TECHNICAL UPDATE

Version 202 (7/2/20) Date Code Update

Figure 1: s84 System Message Example

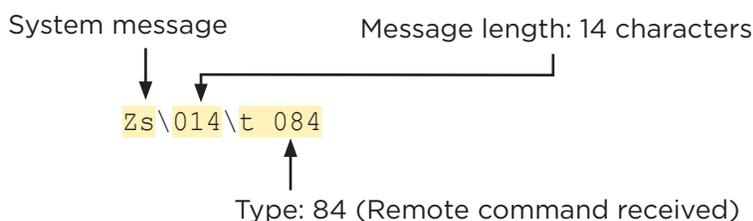
In previous firmware versions, the panel would send an s84 message to the central station every time a command was received when using the Integrator Connection. XR Series panels with firmware Version 202 (7/2/20) and higher that use the Integrator Connection will no longer send s84 (Remote command received) messages to the central station. For more information about system messages, refer to [SCS-VR Reference Guide: Panel Messages \(LT-1959\)](#).
